Service Information

Ref. No. Category Page **Technical** E047/12 1 of 4 S Coverage Date Issued ☐ Distributor only ☐ Please inform your dealers October 31, 2012 Please convey this information to your ■ General Manager Date Revised □ Director ■ Warranty Dept. ■ Parts Dept. ■ Training Dept.
■ Field Rep. Applicable Countries or Specifications Applicable Model Mazda2(DE), Mazda3(BL), MX-5(NC) and Europe Mazda5(CW)

Subject: Discontinuation of Tool (Jack and Wheel Brace)

Mazda2 (DE): Discontinuation of Jack & wheel brace.

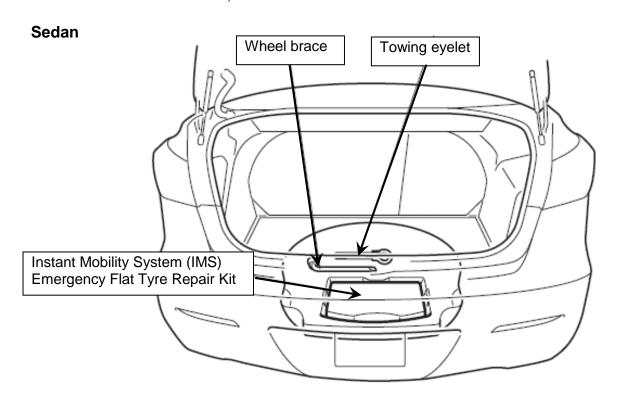
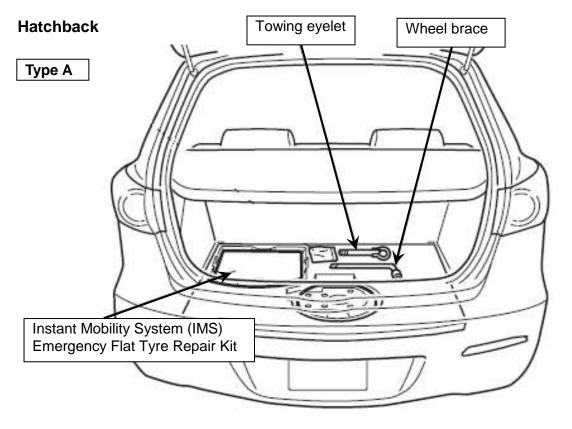
From JMZDE*3** ** 306801 July 01, 2012 From JMZDE*4** ** 471269 July 01, 2012

MX-5 (NC): Discontinuation of Jack.

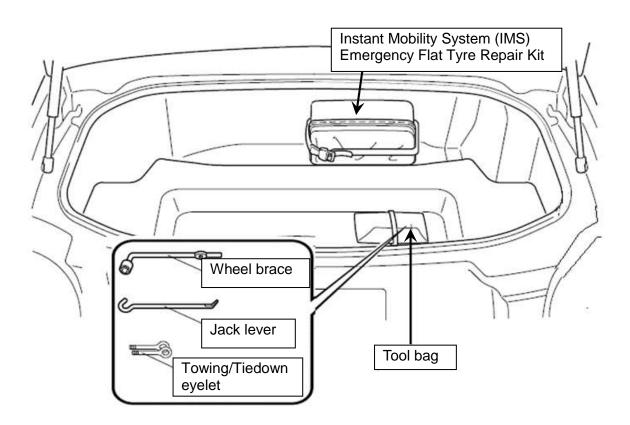
Beginning VIN & Date of Discontinuation
From JMZNC**** ** 266056 July 02, 2012

Mazda5 (CW): Discontinuation of Jack & wheel brace.

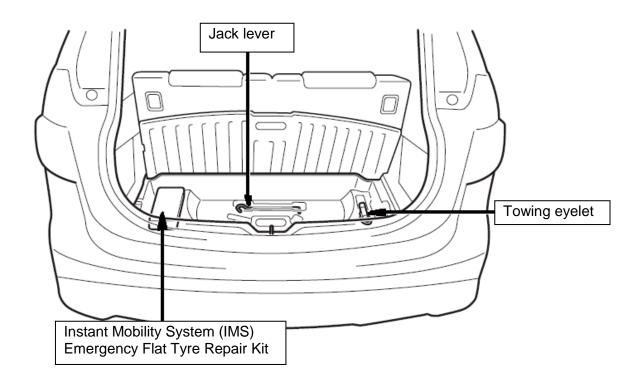
Beginning VIN & Date of Discontinuation From JMZCW**** ** 139773 October 01, 2012
